Summary of November 2015, December 2015 and January 2016 Discussions of Draft Limitations and Conditions and Supplemental Information for the FULL SPECTRUM LOCA (FSLOCA) Evaluation Model (Non-Proprietary)

Summary of November 2015, December 2015, and January 2016 Discussions on Draft Limitations and Conditions and Supplemental Information for the FULL SPECTRUM LOCA (FSLOCA) Evaluation Model

In order to provide context for the discussion in this letter, the draft limitations and conditions proposed by the Nuclear Regulatory Commission (NRC) for the FULL SPECTRUM™ LOCA (FSLOCA™) evaluation model (EM) as discussed in the November 2015 meeting are included here in italics.

Figure 3-3: Figure 17 from AEP-NRC-2009-23, D. C. Cook Unit 2 ASTRUM Analysis Containment Pressure Comparison

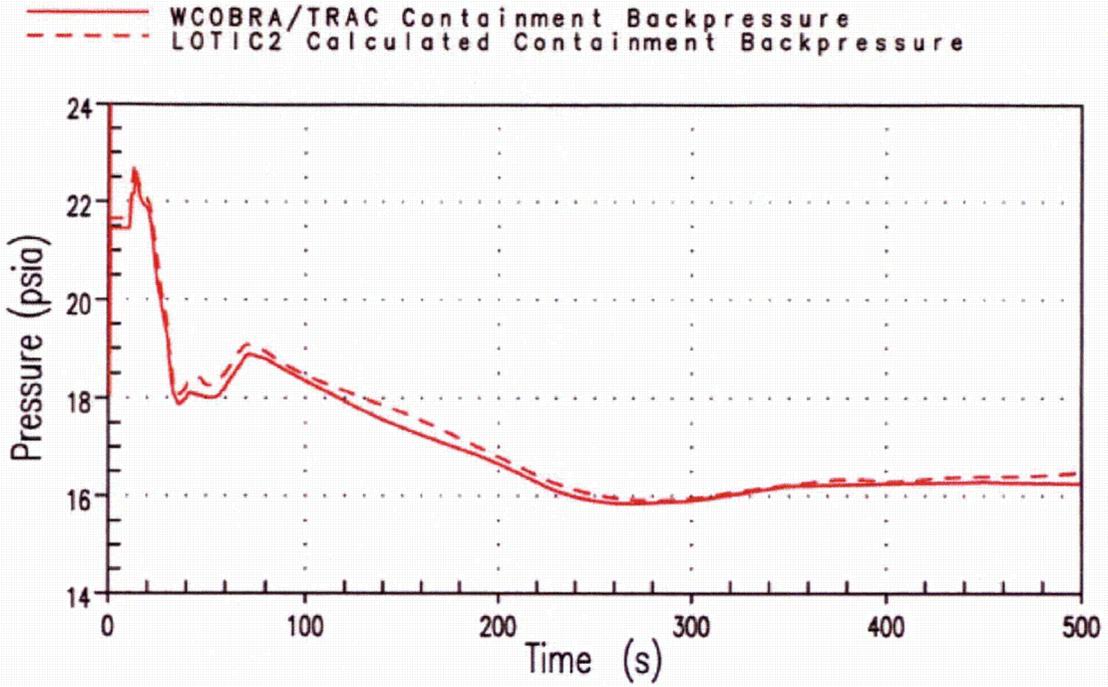
As previously mentioned, the D. C. Cook Unit 2 WCOBRA/TRAC reference transient input containment pressure and the associated LOTIC2-calculated containment pressure are shown in the figure on page 26 of Enclosure 2 to AEP-NRC-2009-23 for the ASTRUM analysis. This figure has been included herein as Figure 3-3.
